Access Compliance Report Public Rights-of-Way (Curb Ramps)

Main Street: O_NEILL_DR Cross Street: NARROW_CANYON_RD Location: SE

ADA ID: RPRK211103151746 Ramp Type: Type 4 - Parallel Initial Pass/Fail: Fail Overall Compliance: No Severity Score: 16

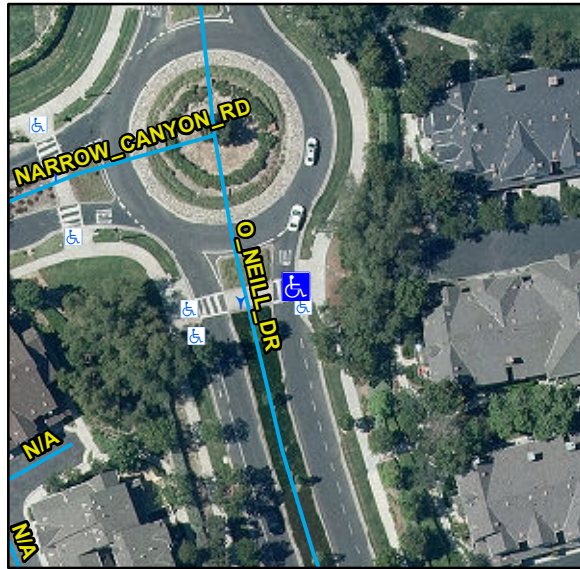
R204.3, R304.3.2, R304.5.3, STD 1115

Compliance	Description	Data	Compliance	Description	Data
N/A	Ramp Length LT (in)	78	N/A	Ramp Length RT (in)	-9999
Yes	Ramp Width LT (in)	50	N/A	Ramp Width RT (in)	-9999
No	Ramp Run Slope LT (%)	8.9	N/A	Ramp Run Slope RT (%)	-9999
No	Ramp Cross Slope LT (%)	2.9	N/A	Ramp Cross Slope RT (%)	-9999
N/A	Landing Present	N/A	N/A	DWS Provided	N/A
N/A	Landing Length (in)	N/A	N/A	DWS Contrast	N/A
N/A	Landing Width (in)	N/A	N/A	DWS Length (in)	N/A
N/A	Landing Run Slope (%)	N/A	N/A	DWS Full Width	N/A
N/A	Landing Cross Slope (%)	N/A		DWS Offset Type	N/A
N/A	Landing Movement Obstructed?	N/A	N/A	DWS Offset Left (in)	N/A
	Landing Movement Type	N/A	N/A	DWS Offset Right (in)	N/A
N/A	Landing Shared	N/A			
N/A	Clear Space	N/A			
N/A	Clear Space To Crosswalk (in)	N/A			
N/A	Marked Crosswalk 1	Yes	N/A	Marked Crosswalk 2	N/A
	Crossing 1 Direction	W		Crossing 2 Direction	N/A
	Marked Crosswalk 1 Width (in)	144		Marked Crosswalk 2 Width (in)	N/A

Remove & Replace Entire Ramp.
